FAQ Number 06-0012 Revision 3

FAQ Title Determining Manual Actions that Require a Change Evaluation during Transition

Plant: Harris Nuclear Plant Date: 03/22/2007
Contact: Elizabeth Kleinsorg Phone: 704.651.5548
Email: ekleinsorg@haifire.com

Attachment to FAQ 06-0012 Revision 3
Excerpt from NEI 04-02 Revision 1 with Changes Tracked

Figure B-4 General Process to Transition Operator Manual Actions

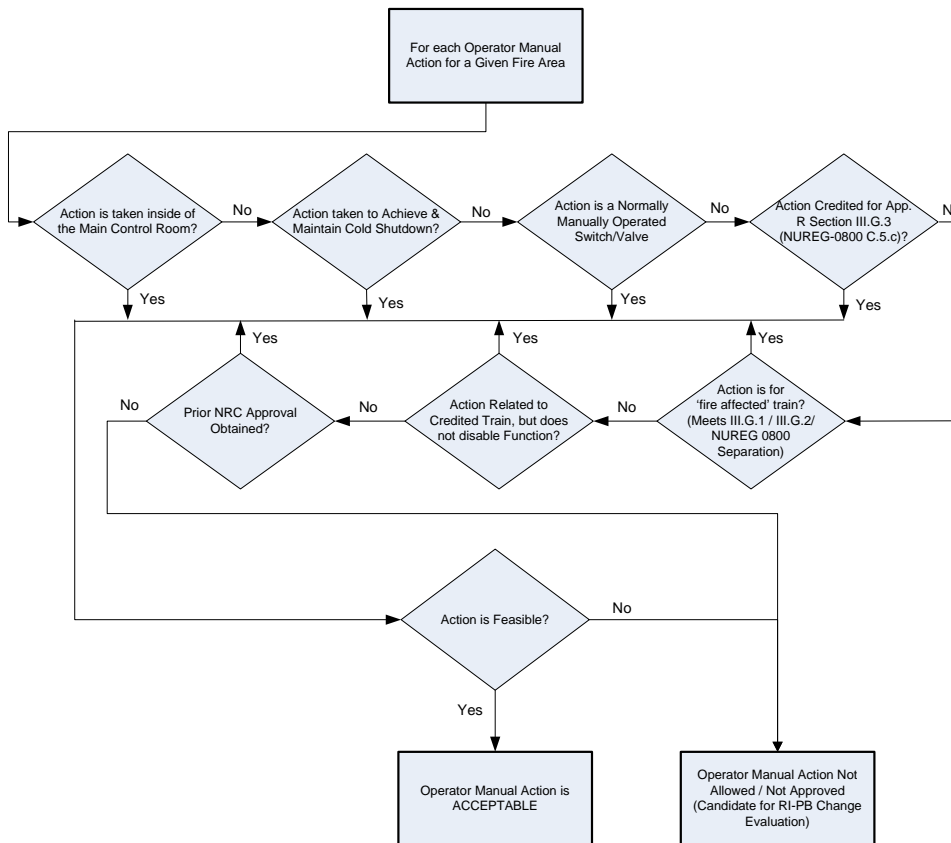
Figure B-4 depicts this general process for determining whether a transitioning operator manual action to NFPA 805 recovery action requires a change evaluation.

Figure B-5 Allowed Operator Manual Action in Fire Area Meeting 10 CFR 50, Appendix R, Section III.G.1 Separation Criteria

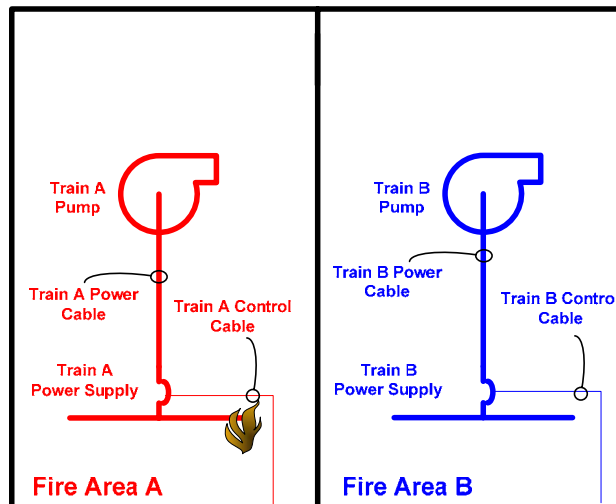
- Operation of fire affected equipment for fire areas that meet the separation requirements of Section III.G.1 of 10 CFR 50, Appendix R (or applicable sections of NUREG-0800). See Figure B-5.

Fire Area A and B meet the separation criteria of 10 CFR 50 Appendix R Section III.G.1. A postulated fire in Fire Area A could result in the spurious starting of the Train A pump, which can be mitigated by an operator manual action to de-energize the Train A Power Supply to stop Pump A.

Figure B-6 Allowed Operator Manual Action in Fire Area Meeting 10 CFR 50, Appendix R, Section III.G.2 Compliant – Operator Manual Action for Fire Affected Train

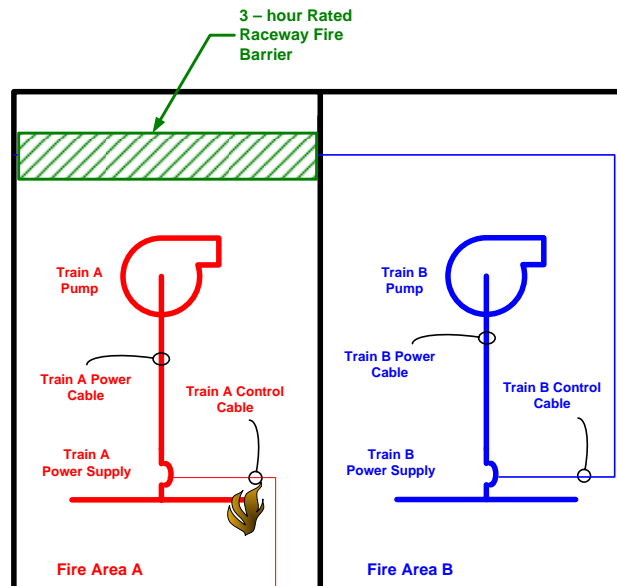
- Operation of fire affected equipment for fire areas that meet the protection requirements of Section III.G.2 of 10 CFR 50, Appendix R (or applicable sections of NUREG-0800) for redundant trains. See Figure B-6.

Fire Area B meets the separation criteria of 10 CFR 50 Appendix R Section III.G.2.a. A postulated fire in Fire Area A could result in the spurious starting of the non-credited Train A pump, which can be mitigated by an operator manual action to de-energize the Train A Power Supply to stop Pump A. This is functionally equivalent to Case in Figure B-5.

Figure B-7. Allowed Operator Manual Action – In Credited Success Path – Common Tank Suction

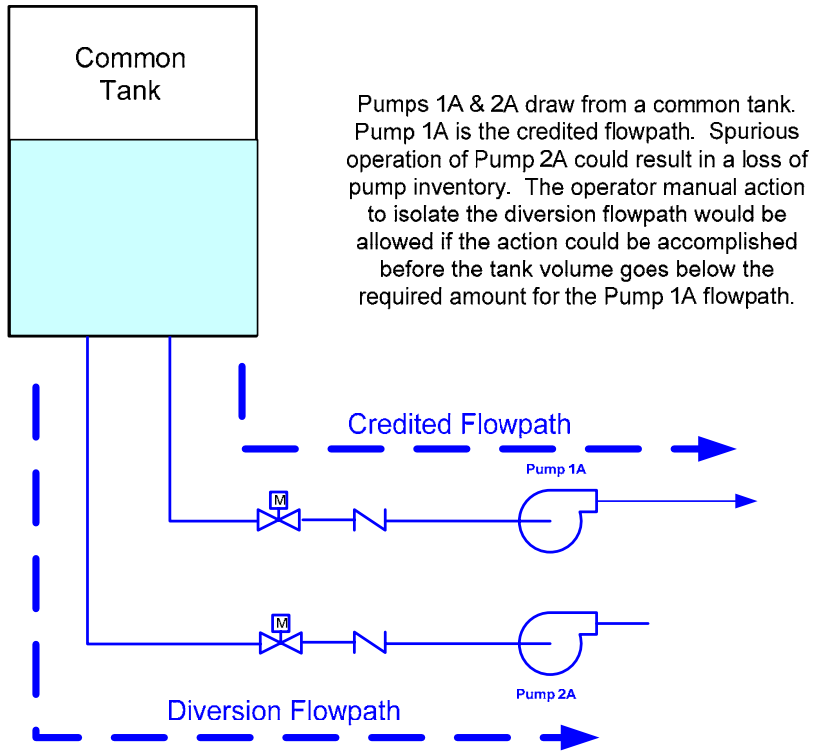
During the June 9, 2006 public meeting the following example was specifically discussed: *Two redundant trains taking suction from a common tank. Provided the manual action can be accomplished prior to the tank volume going below the minimum required volume to support the credited function the action would be allowed and therefore not require a change evaluation.* (Figure B-7)

Figure B-8, Allowed Operator Manual Action – In Credited Success Path – Auxiliary Feedwater Flow Diversion

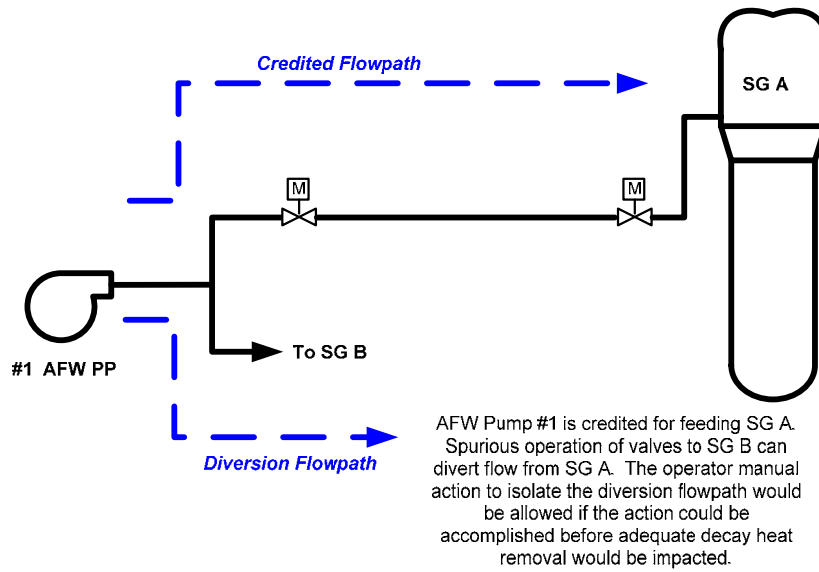
A second example is the credited function is to inject water to the Steam Generator (reactor) and a spurious actuation causes a diversion from the credited flow path. Provided the minimum required injection flow can be maintained and the operator action can be accomplished prior to the function being disabled. (Figure B-8)
